STATKRAFT / ELECNOR / ANDRITZ
Feedback to SONI SCU Grid Code Modification Consultation
(particularly related to clause CC.S3.1.3.2 and the Availability Definition)

Figure 1 – Possible default interpretation for SCUs that can provide a greater reactive power capability than the minimum Grid Code requirement

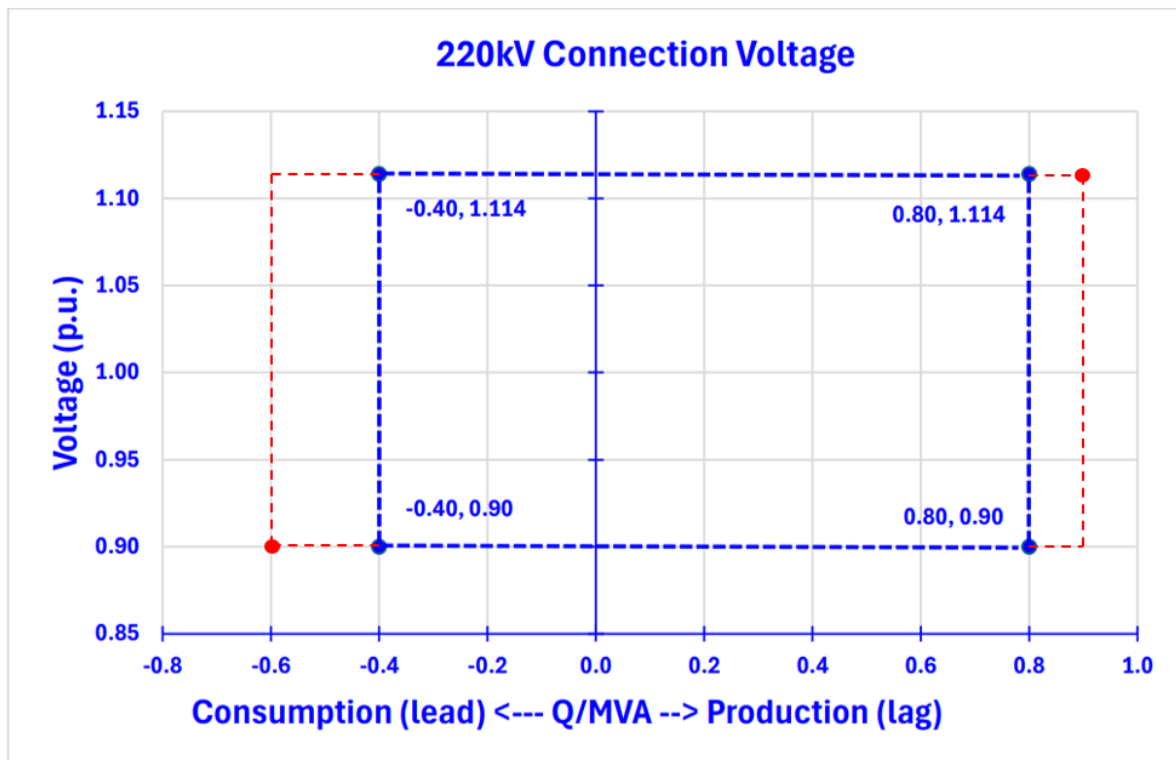
For example, an SCU contracted under the LCIS Arrangements is incentivized to provide reactive power capability ≥ 0.9 p.u (lagging) and ≤ -0.6 p.u. (leading) in order to achieve the maximum possible Reactive Power Product Scalar. In the absence of any explicit clarification, a likely default interpretation of the Grid Code for such an SCU could be that the reactive power capability at ≥ 0.9 p.u (lagging) and ≤ -0.6 p.u. (leading) must be provided along the entire voltage range (i.e. from 0.9 p.u. to 1.114 p.u. for a 220kV connection). This is represented by an extension (red dashed line) of the proposed rectangular grid code requirement as shown below.

- The operational points shown in red at the top right (max voltage, max var) and bottom left (min voltage, min var) of the extended rectangular box in Figure 1 are challenging for thermal and stable operation of a synchronous condenser machine.
For example, to meet the top right corner in the over-excited range, an SCU would need to operate with an overvoltage (e.g. >1.05 p.u.) on the SCU machine terminals. Similarly, to meet the bottom left operating point in the under-excited range, the SCU would need to regulate to a higher than nominal target voltage on the SCU machine terminals (e.g. >1 p.u.). These are not ideal operating conditions from either an SCU or System Operator perspective.

Therefore, the only option to comply with the requirement at these extremes indicated in Figure 1 would be to either oversize the synchronous machine and/or oversize the power transformer neither of which is economical to do. It is also important in this context to recognise the difference that exists between units that produce Active Power and units that do not produce Active Power (e.g. SCUs).

Figure 7 : Exemplary specified operation range of a synchronous condenser plant at PCC – rectangular shape (blue) vs. different extent of clipped corners (green).

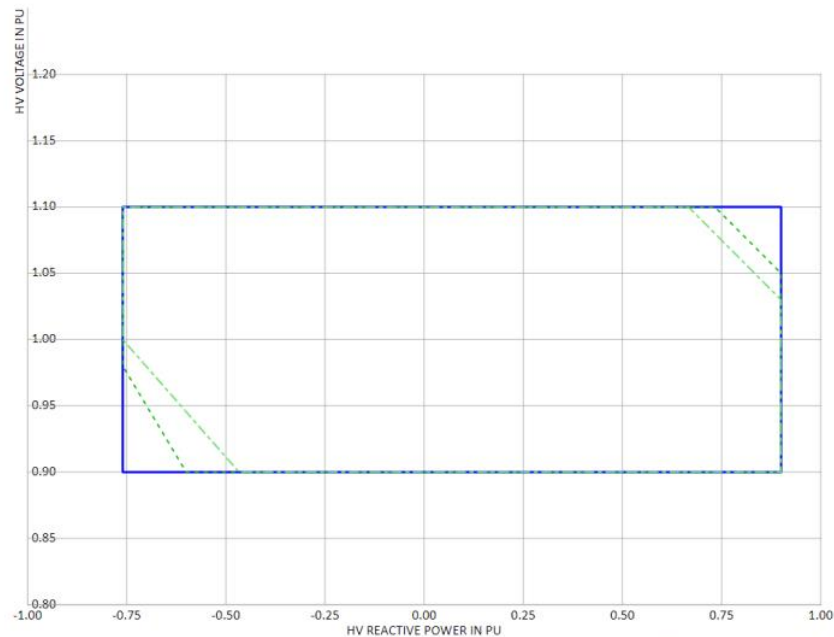
A report on the *Design Aspects of Synchronous Condensers* [1] submitted by ANDRITZ to CIGRE in the 2024 Paris Session makes this very case that it is neither the optimal technical or economic solution to design and operate a synchronous condenser at these extreme points [**emphasis added**]:

"As those areas are determining the synchronous condenser design, restricting operation in those areas or even clipping these two extreme corners **will yield a more economic condenser solution**. Furthermore, it was recognized that the **lower left and upper right operating corners are not good engineering practice in terms of voltage control** ([8])."

Figure 9 - (Solution A)

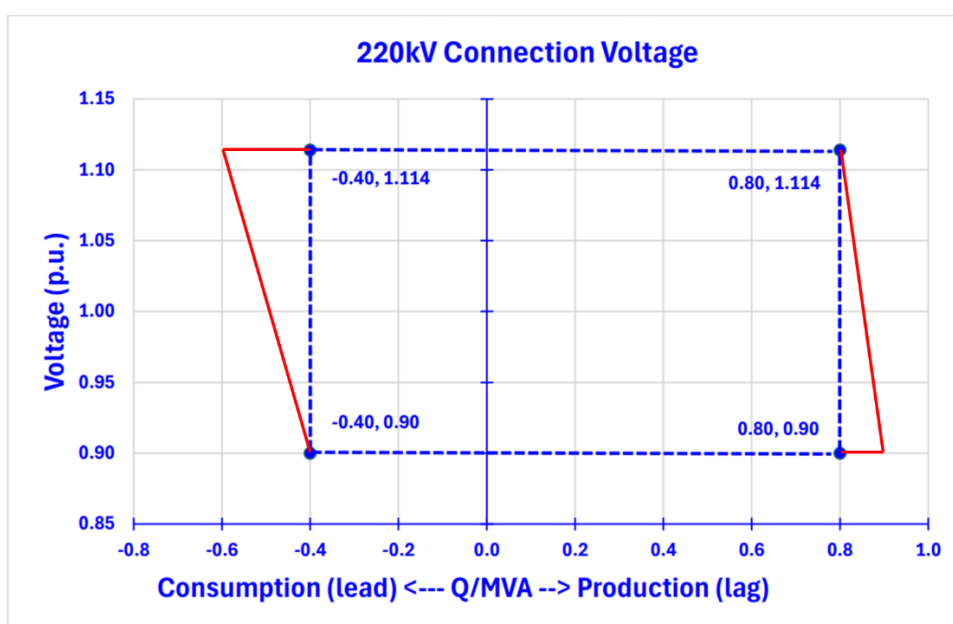
In order to avoid any ambiguity in the Grid Code, we propose that the following text (shown in the black box below) is added to clause SCU1.4.6.3. This point is further represented by the red lines in Figure 9 below (which are shown for illustrative purposes only and not intended for inclusion in the Grid Code).

SCU1.4.6.3 Synchronous Condenser Units connecting to the Transmission System shall comply with the following Reactive Power requirements at the Connection Point. The Synchronous Condenser Unit shall be capable of moving to any operating point within its U-Q/MVA profile in appropriate timescale to target values. The appropriate timescale shall be identified during the TSO's Connection Offer process.

Where Synchronous Condenser Units can provide reactive power capability beyond the envelopes shown, the additional capability may not have to be provided across the full voltage range and the slope for the additional capability shall be agreed between the TSO and the Synchronous Condenser Operator.

Figure 10 - (Solution B)

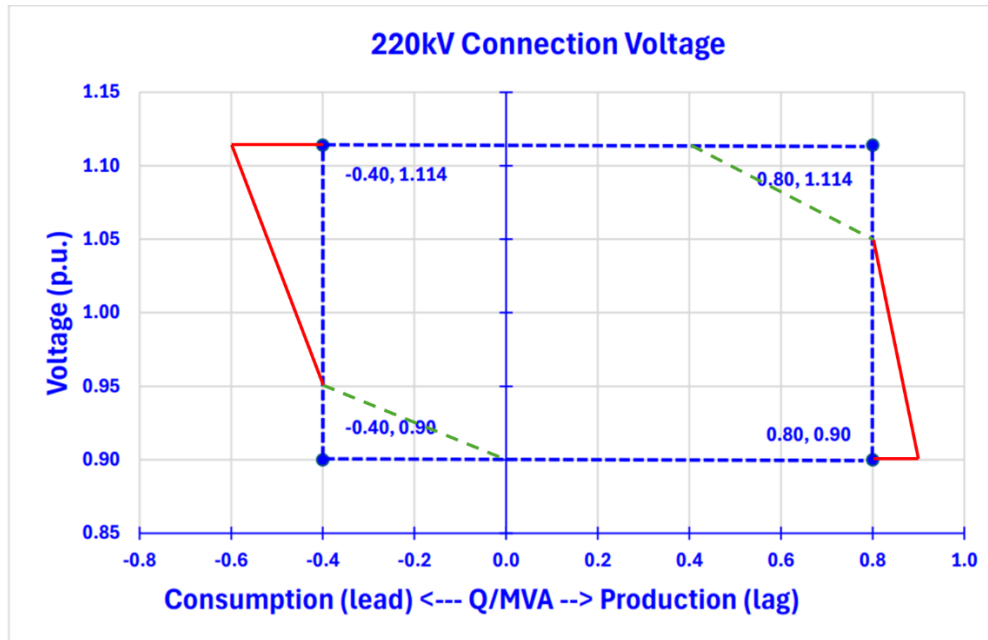
Furthermore, for the reasons outlined in Section 2 and Section 3 and the limited benefit to the System Operator outlined in our original feedback referenced in Section 1, we believe there is a strong case that the region within the proposed rectangular reactive power requirement (i.e. ≤ 0.8 p.u and ≥ -0.4 p.u) should also be clipped as shown in Figure 10 below. This is represented by the green dashed lines which is proposed to be included in the Grid Code if Solution B is accepted. The continuation of the lines outside the minimum Grid Code requirement equivalent are shown again in red for illustrative purposes only and not intended for inclusion in the Grid Code, as this would be already addressed by inclusion of the text proposed in Solution A.
